Client / project
Reading Borough Council
Amethyst Lane

Dwelling Type
3B5P House
Type B

drawing number
HTA-A_DR_0301

revision
E

Roof Level

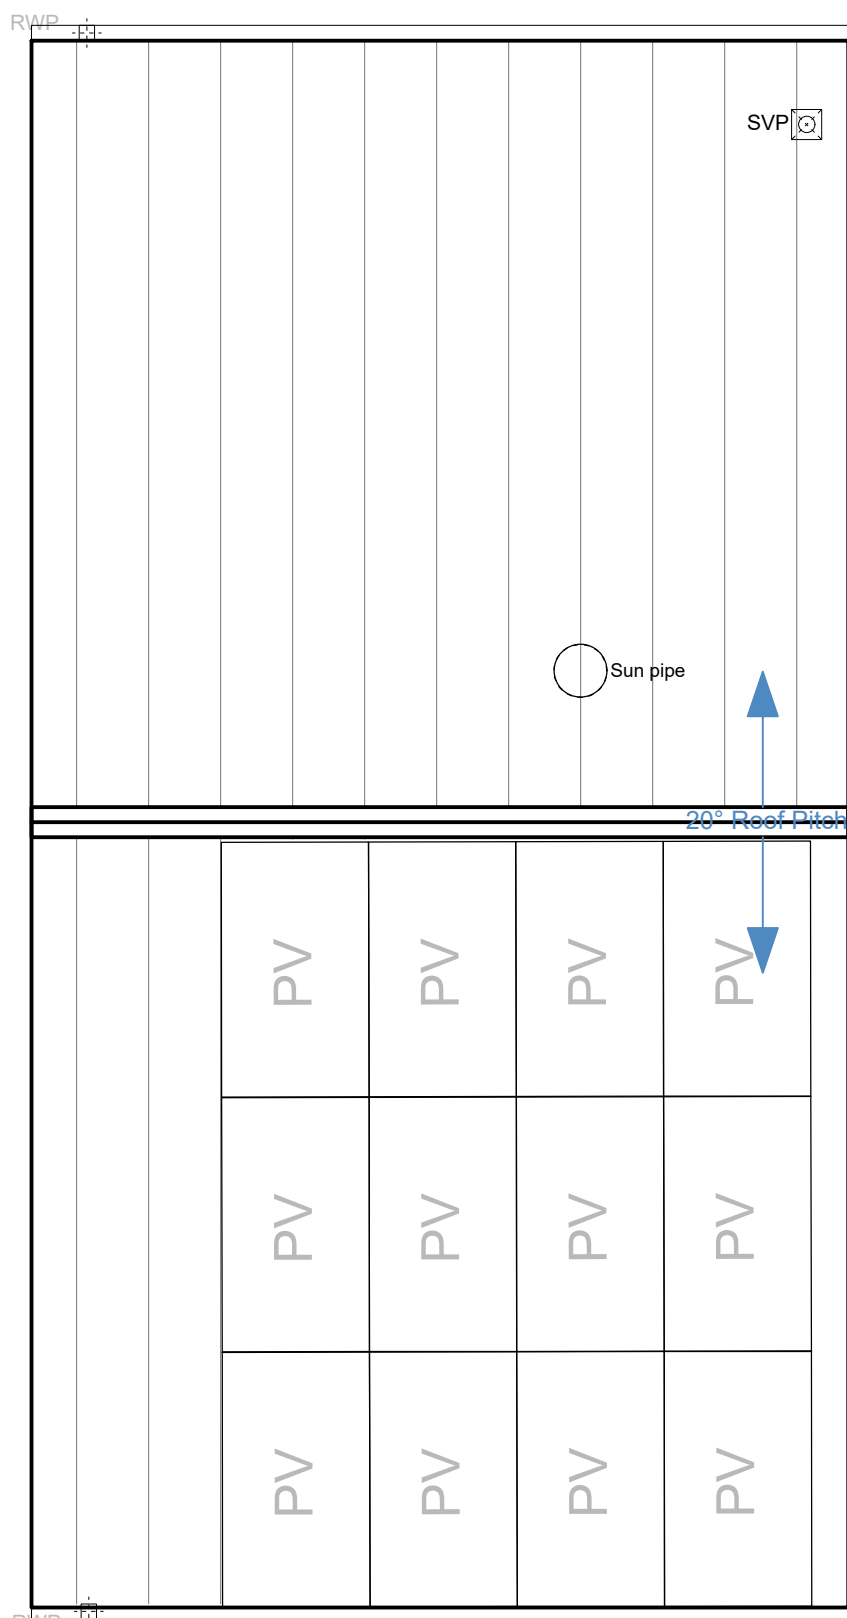
- Unit type -**
- Solar shades removed (not required for overheating strategy)
 - Site setting out updated to reflect design development (wall thickness and brick dimension coordination)
 - Updated PV Panel arrangement (additional PV Panels added)
